Drawing Title: **EROSION CONTROL PLAN**

Project No.: 3200006-000  
Scale:   
Drawing No.: **C700**

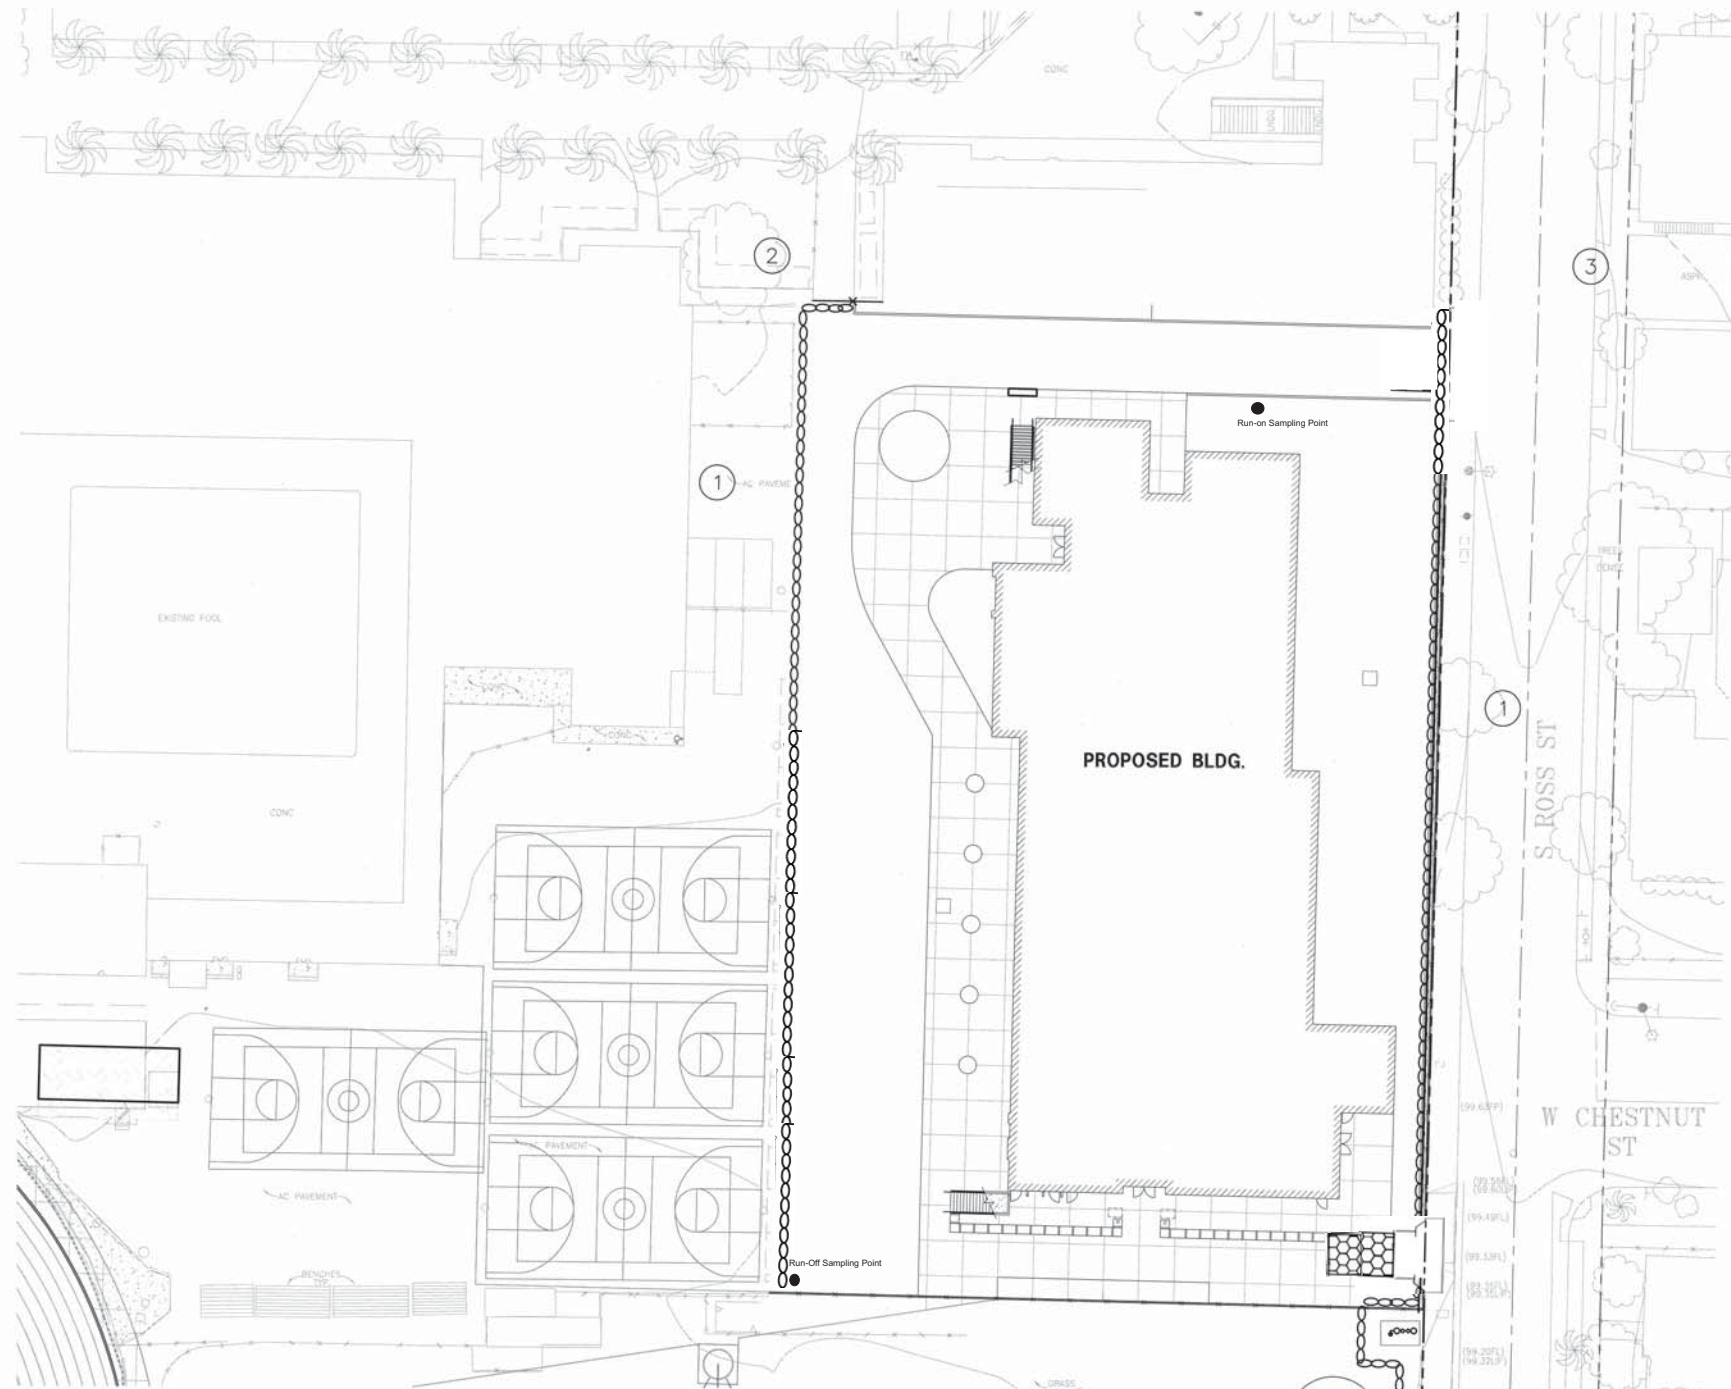
WPCD Revised per QSD - Michael R. Alberson  
CPSWQ, CPESC, CISEC, CESSWI, REA 1, TOR

Gravel Bag Berm 3/4" rock fill - 2 high

Stabilized Construction Entrance 30' x 50'
